Change Notification

4M3F Change No.: PCN230210SM

Since 2006 Schaffner is in the process of moving from pad printing to labels for all filters. To further standardize and automate label creation and production, 7 basic standard sizes for either horizontal or vertical use have been defined and implemented in SAP/Codesoft.

Specific examples

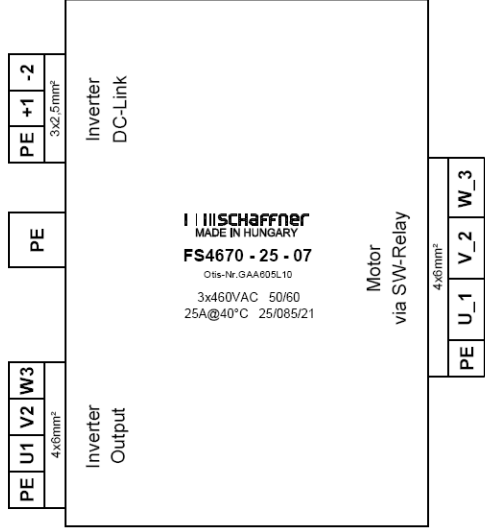
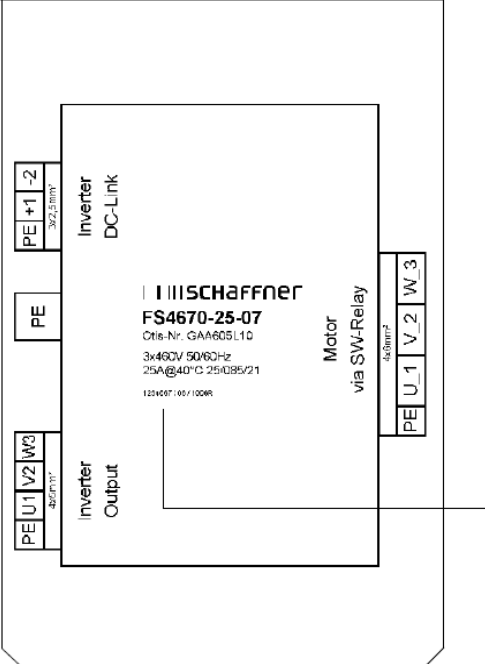
The following are the main differences compared with the old pad printing in accordance with the EMC Product Creation Guideline (PCG):

- A Schaffner internal country code replaces the “Made in XXX” country of origin information

- The work order number is now also visible for better traceability

- “warnings” are shown as a symbol and written in English only
- Electrical schematics can no longer be printed on filters since this is not supported by the software used.
